Attorney Docket No. HHI-032US
US Serial No. 09/889,916
Group Art Unit 1725

REMARKS

Version With Markings to Show Changes Made

FIG. 2

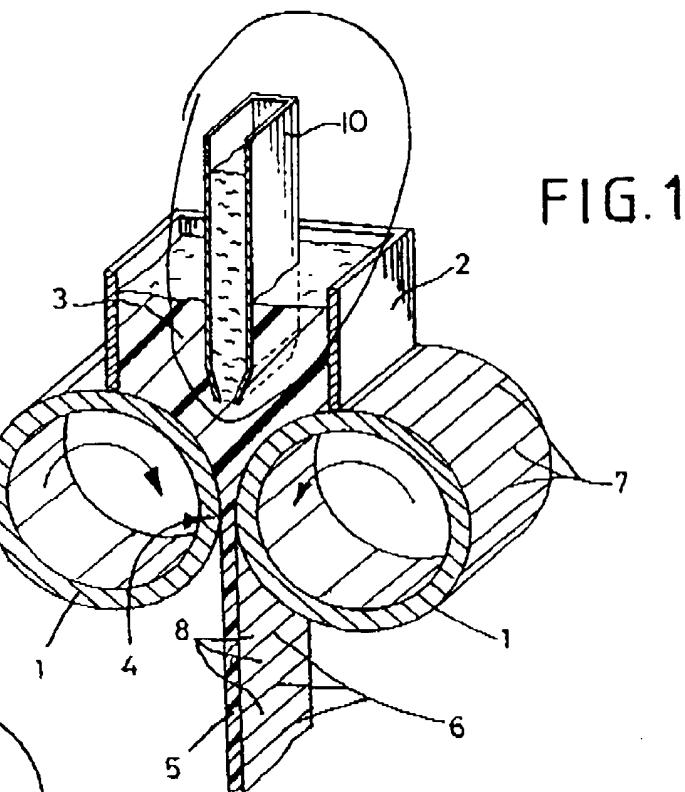
The drawing is objected to in that it does not find support for the claimed feature "means for adding fibers, particles or similar additive before the molten light metal enters the gap." Applicant submits a corrected drawing herewith. Applicant further submits that no new matter is involved, as support is provided in the specification at least at page 6, lines 15-26, and claim 1.

In the devices of both Fig. 1 and Fig. 2, an additional feed unit 10, e.g., for granular or powder-type particles or fibers may be provided. Examples of possible granular or powder-type particles are those of SiC, Al₂O₃, or carbon. The method of feed for the particles or fibers may be to add these to the molten metal or to add them to the molten metal up to a point immediately before gap 4 such that a specified distribution of particles or both fibers and molten magnesium is assured – and thus the consistency of the product as well. Fibers may as required be added in loose form as bulk material, or as nonwoven, woven or knit material, or in analogous form such that this method of adding the fibers ensures especially uniform product characteristics for the fiber-containing pellets. An especially advantageous method may be to homogenously distribute the particles or fibers at an external site, e.g., by mechanical or induction stirring.

Corrections to Figures 1 and 2 are shown in red and filed with this Response.
